Geotechnical Exploration, Inc.

Job No. 16-11251

Subject: **Response to City of San Diego Cycle Review Comments LDR-Geology: Project No. 508125, Cycle Issue 11**
Proposed Foxhill Residence
7007 Country Club Drive
La Jolla, California

PLOT PLAN AND SITE SPECIFIC GEOLOGIC MAP

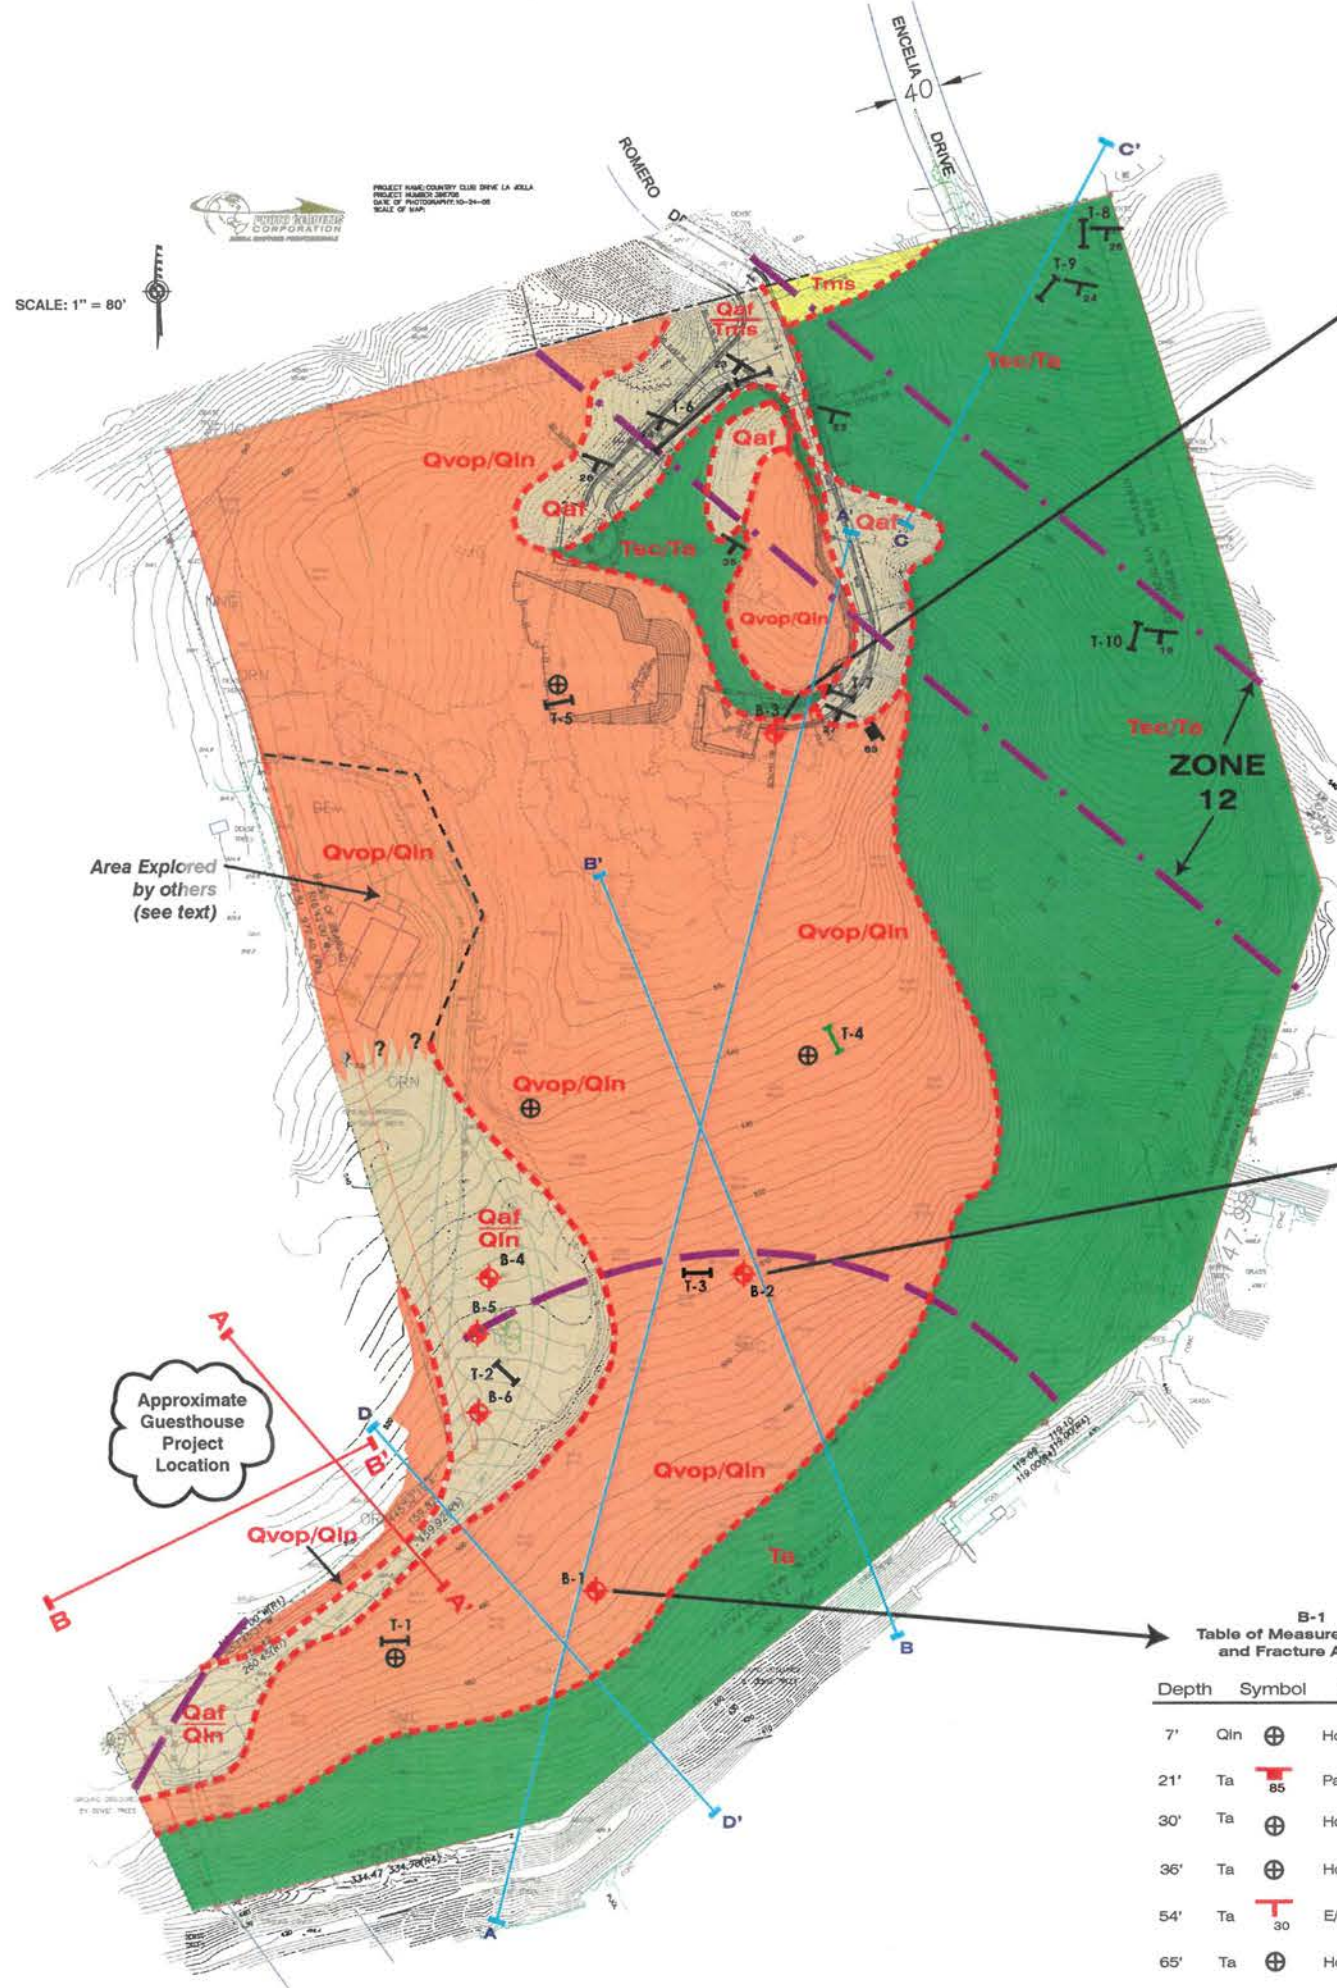
Issue No. 4: The project's geotechnical consultant must circumscribe the area of remedial grading recommended on the geologic/geotechnical map. (Outstanding Issue from Cycle 2)

GEI Response: We have included a site specific geologic/geotechnical map that circumscribes the area of recommended remedial grading on a topographic-based map with this update letter as Figure No. Ia.

(UPDATED) SITE PLAN AND GEOLOGIC MAP

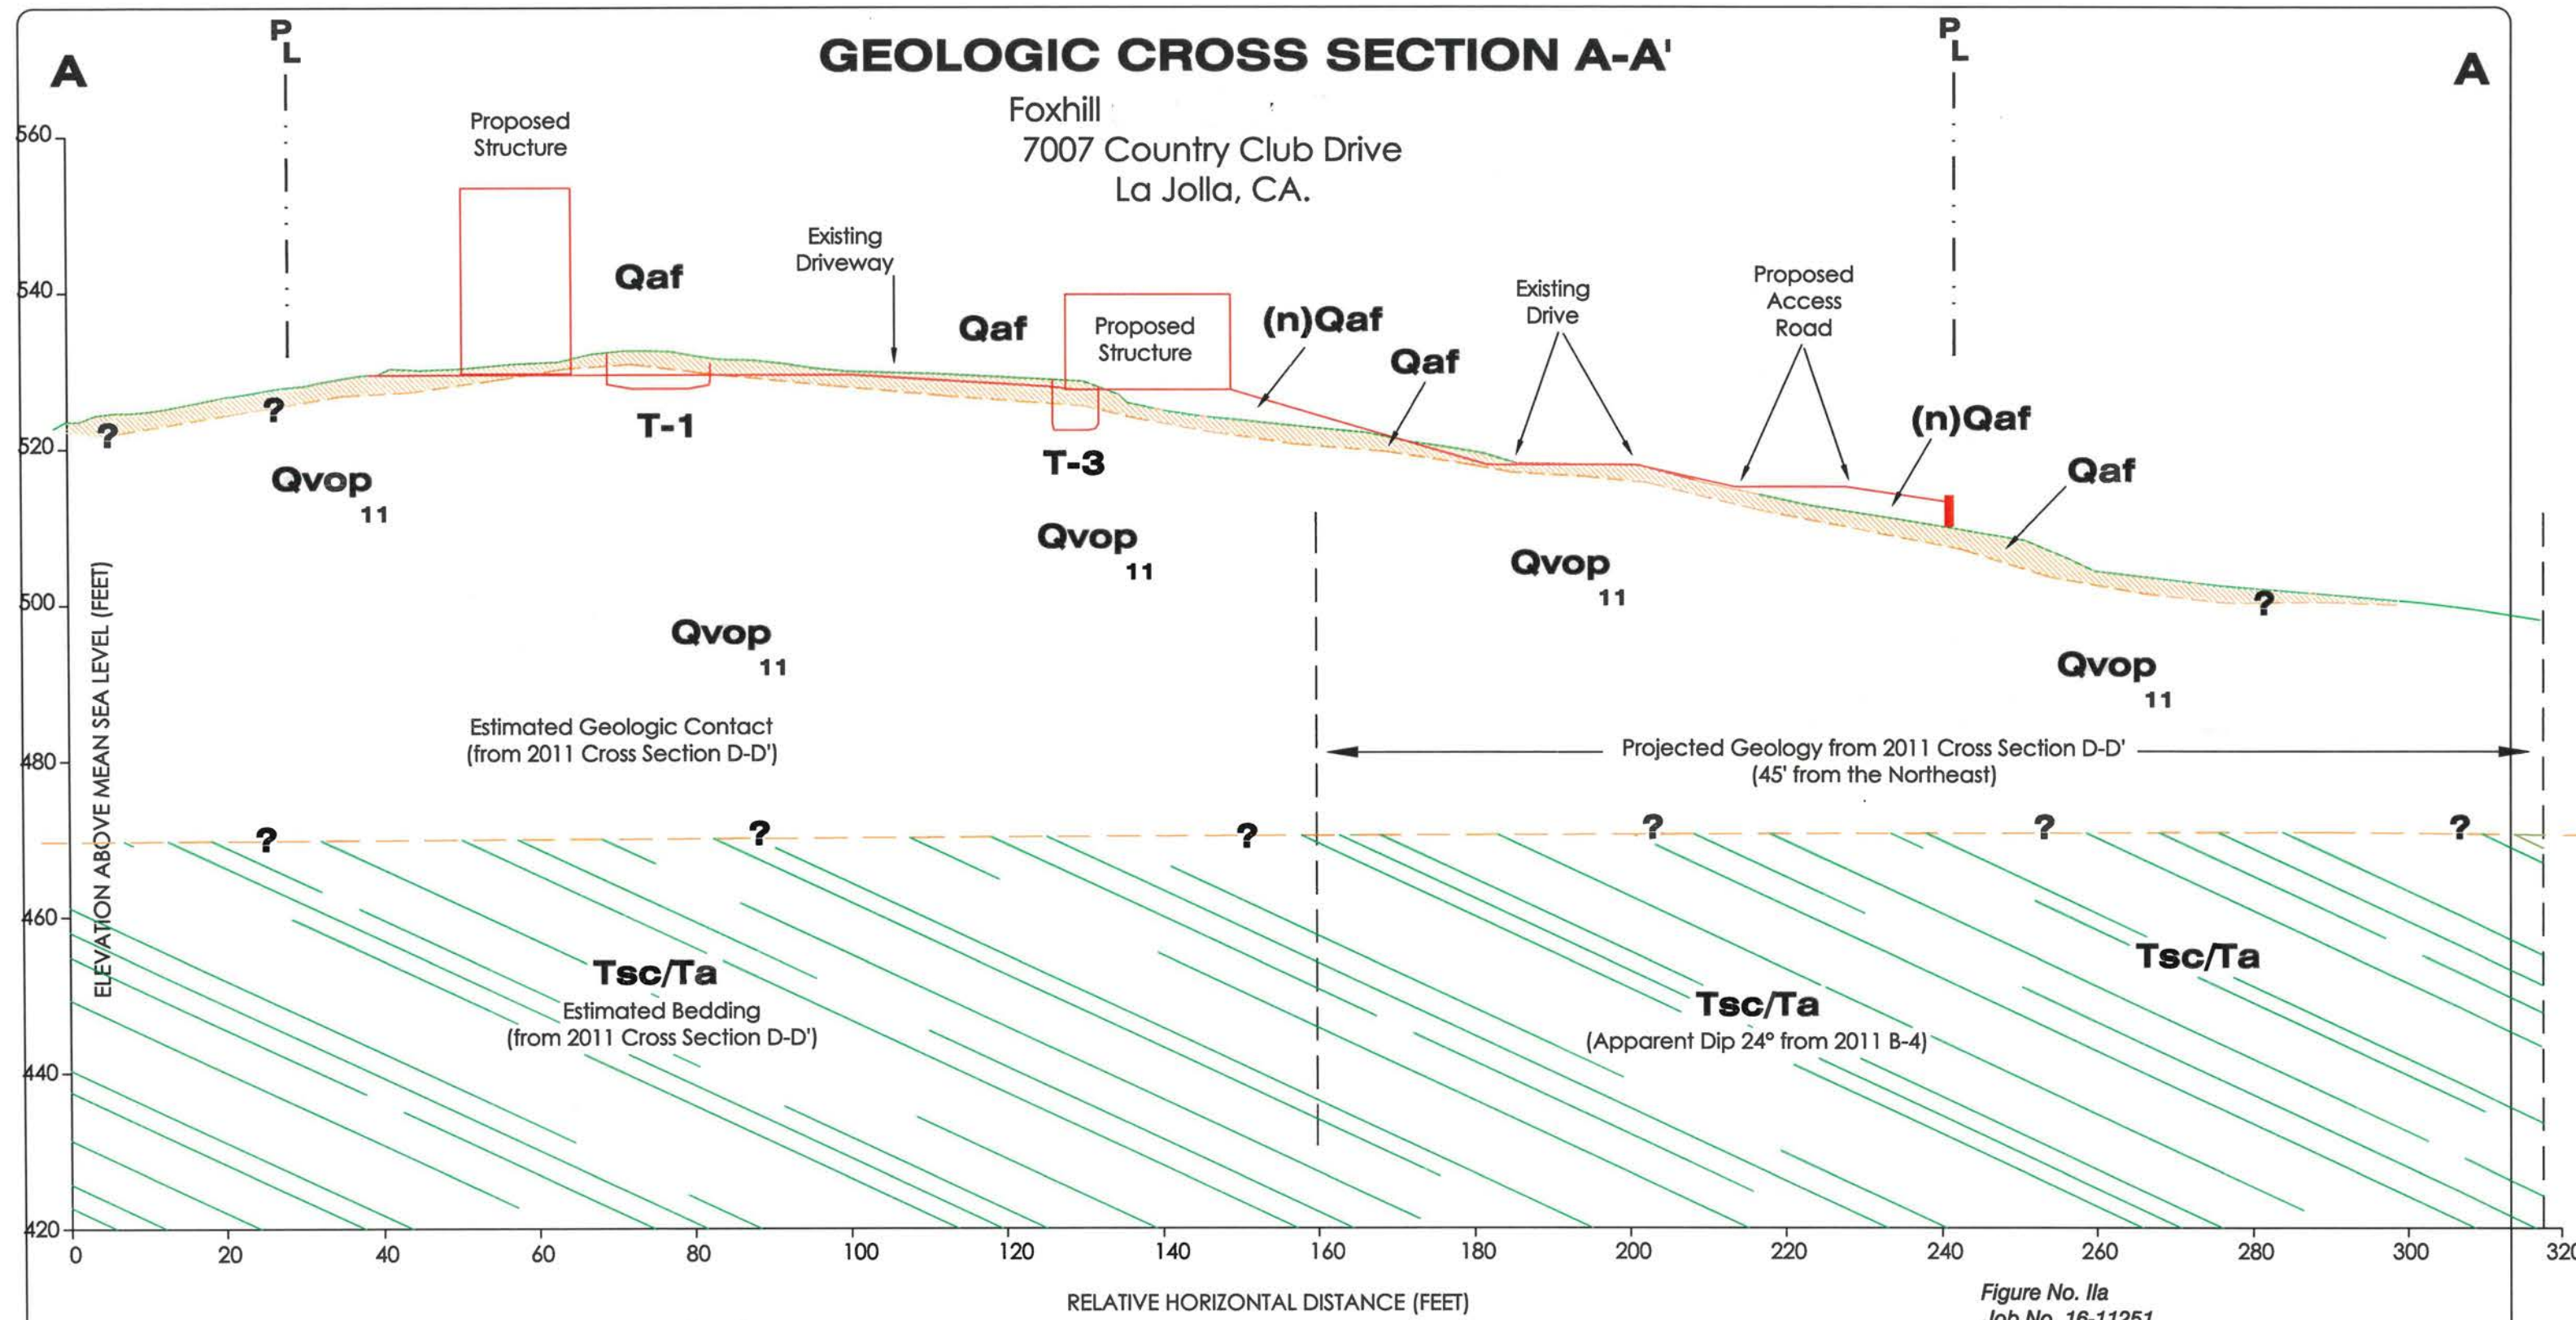
Issue No. 6: According to the San Diego Seismic Safety Study Geologic Hazard Maps, a portion of the access road for the guesthouse is located in geologic hazard category 22, indicating potential slope instability, possible or conjectured landslide. Clarify if the site or any portion of the site is located on or adjacent to a landslide. Provide the rationale and site-specific physical evidence used to support a determination regarding the presence or absence of landsliding at the site. (Outstanding Issue from Cycle 2)

Along with geologic cross-sections A-A' and B-B' provided for this update letter, we have included a revised geologic cross-section D-D' and exploratory boring (B-1) log for the adjacent parcel from our "Report of Preliminary Geotechnical and Geologic Investigation," dated November 16, 2011. Please, refer to Figure Nos. Ia-b for the geologic cross-section locations on the Plot Plans with Site-Specific Geology. Refer

GEOLOGIC CROSS SECTION A-A'

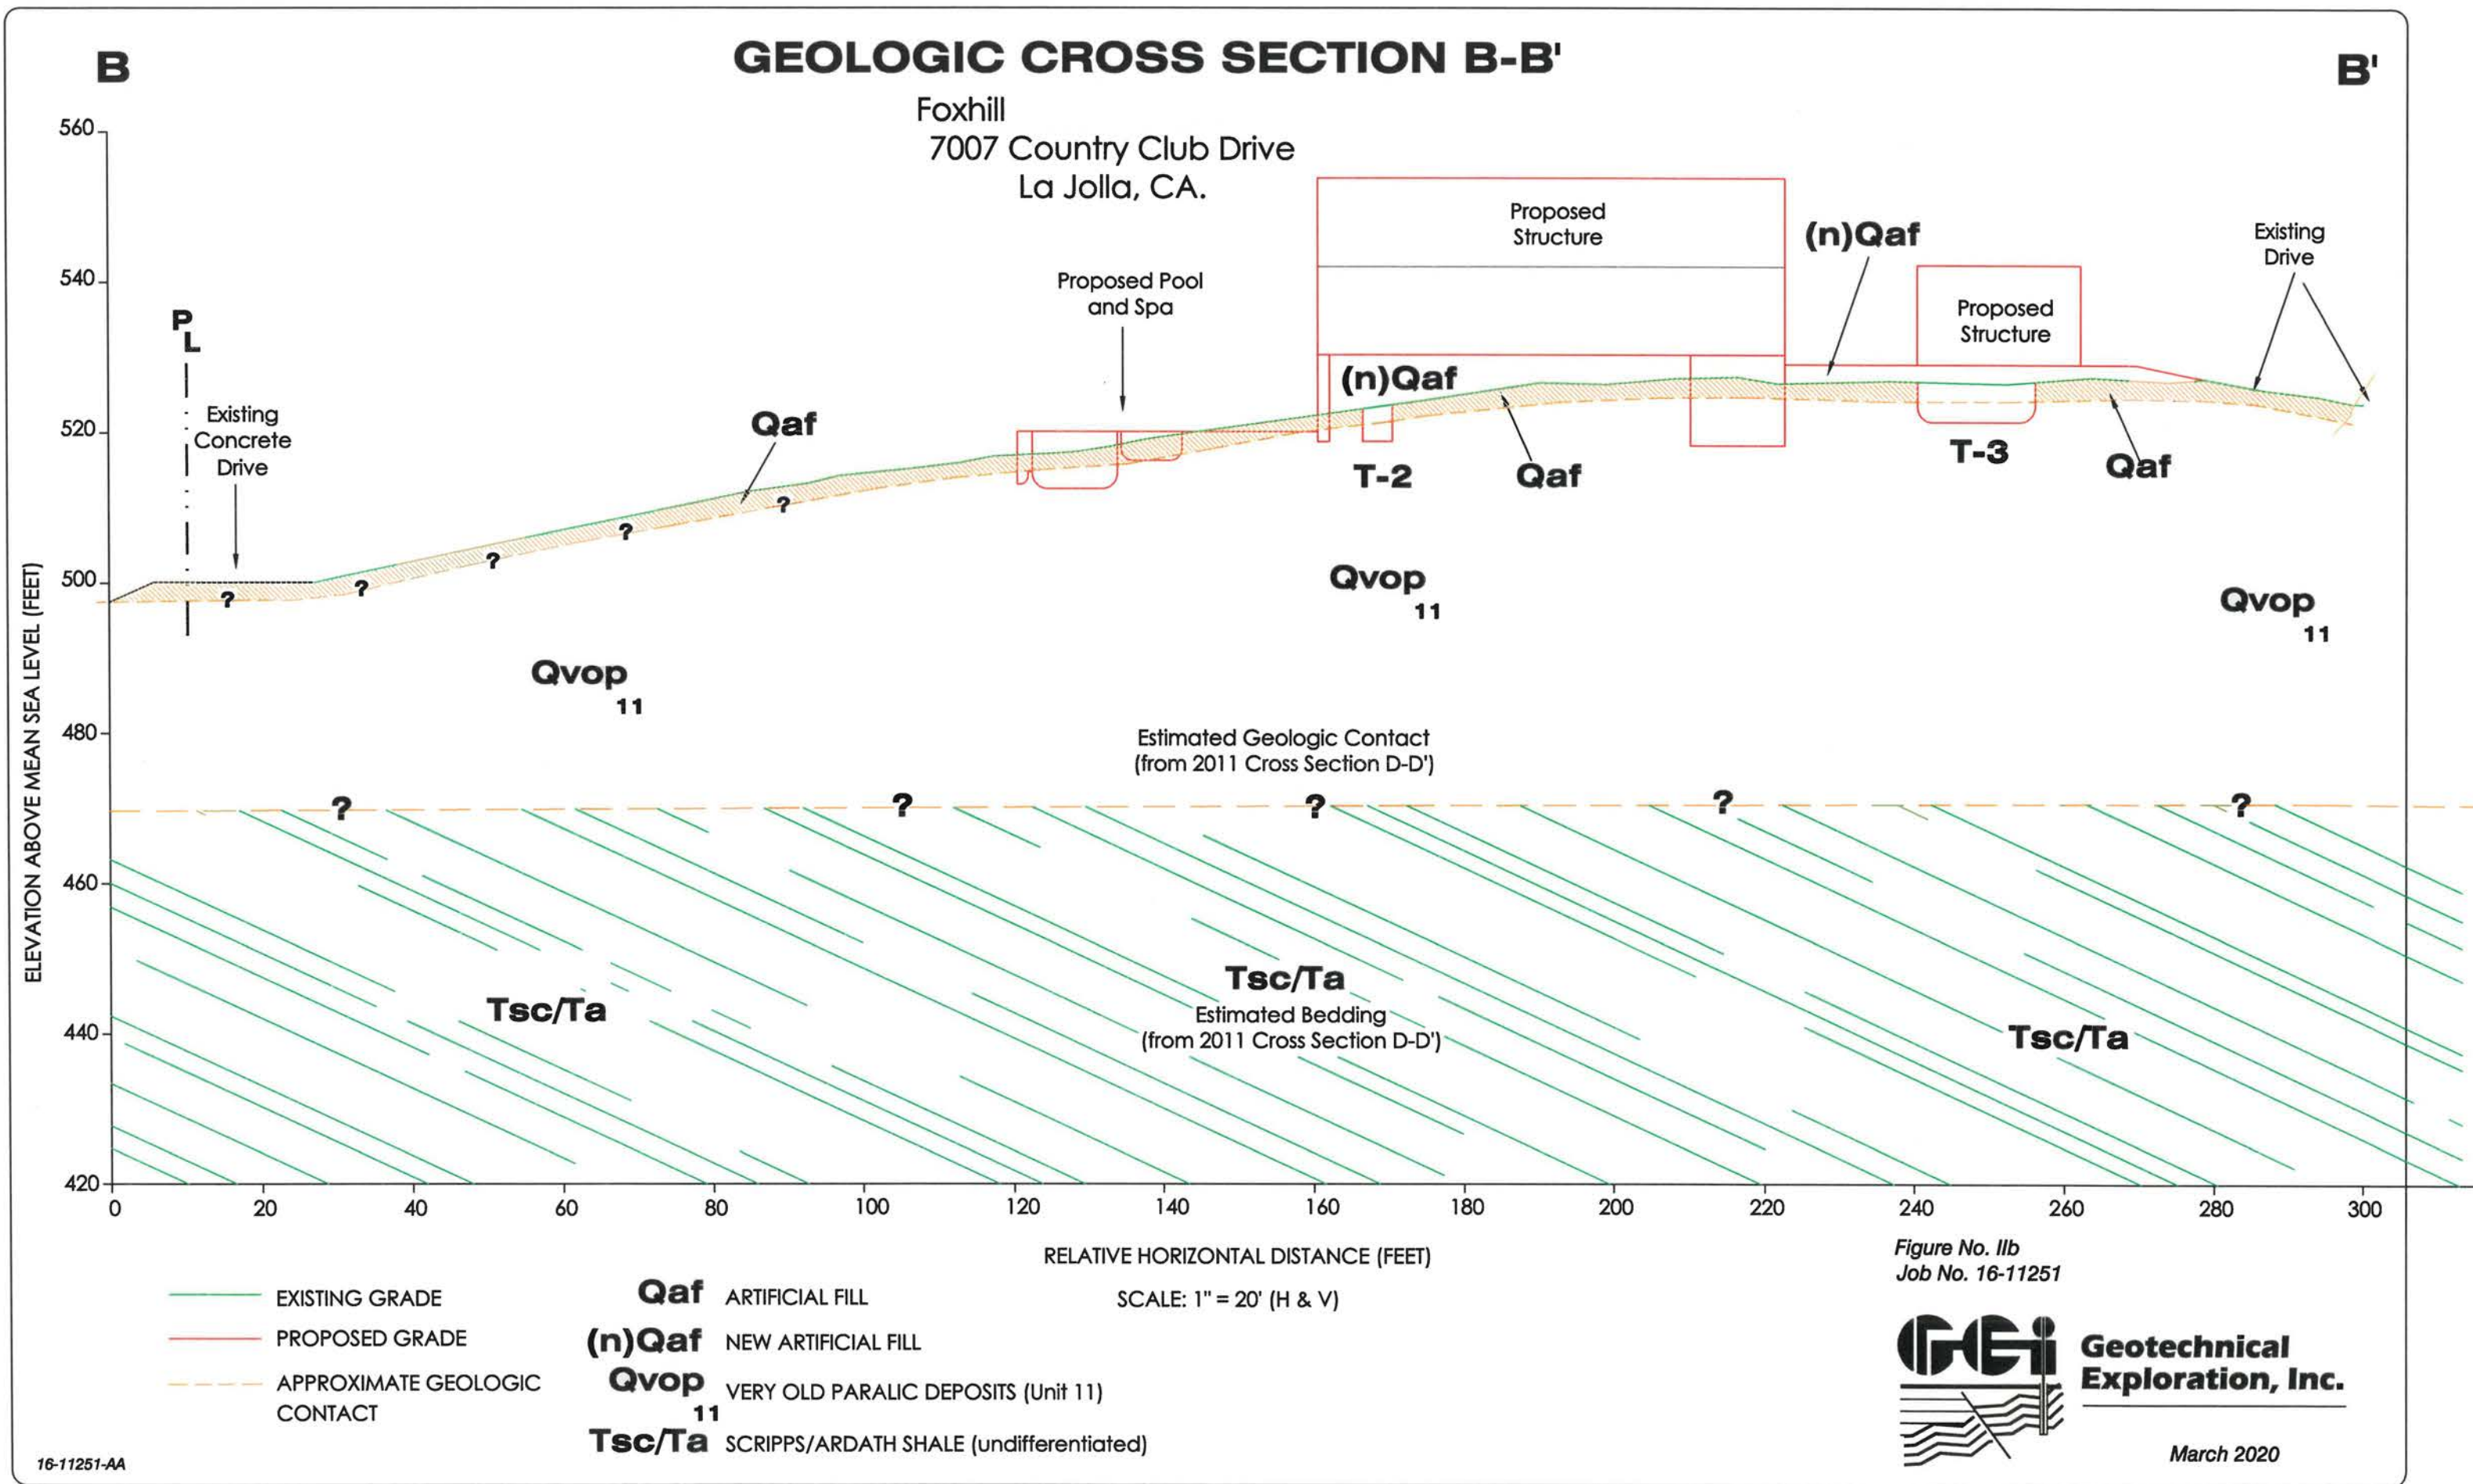
Issue No. 5: Provide geologic/geotechnical cross-sections representative of the site conditions and proposed grading. (Outstanding Issue from Cycle 2)

GEI Response: We have included geologic/geotechnical cross-sections representative of the site conditions and proposed grading from the referenced architectural and grading plans with this update letter as Figure Nos. IIa-b. In addition, we have included a revised geologic cross-section D-D' from our "Report of Preliminary Geotechnical and Geologic Investigation, Copley Press Residential Project," dated November 16, 2011, of the adjacent parcel (APN 352-300-04-00) and a portion of the subject site. Please, refer to Figure Nos. Ia-b for the geologic cross-section locations on the Plot Plans with Site-Specific Geology. Refer to Figure No. IIc for the revised Geologic Cross-Section D-D'.
